XC27x5X Derivatives

16/32-Bit Single-Chip Microcontroller with
32-Bit Performance

Edition 30.01.2009

Figure 1 Loss of Arbitration

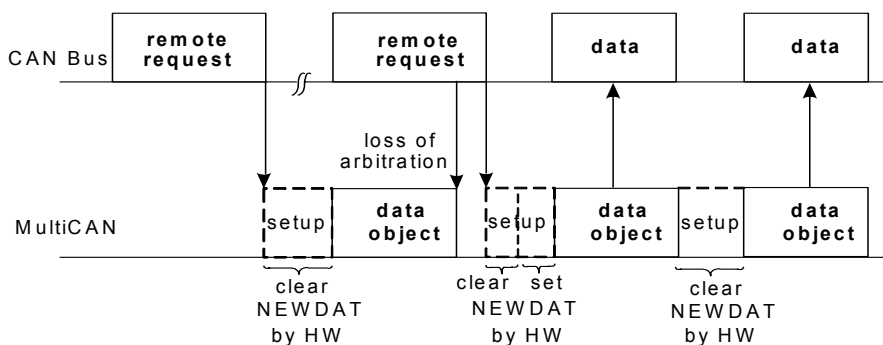
Assume the following scenario: A first remote frame (dedicated to a message object) has been received. It performs a transmit setup (`TXRQ` is set) with clearing `NEWDAT`. MultiCAN starts to send the receiver message object (data

frame), but loses arbitration against a second remote request received by the same message object as the first one (`NEWDAT` will be set).

When the appropriate message object (data frame) triggered by the first remote frame wins the arbitration, it will be sent out and `NEWDAT` is not reset. This leads to an additional data frame, that will be sent by this message object (clearing `NEWDAT`).

There will, however, not be more data frames than there are corresponding remote requests.
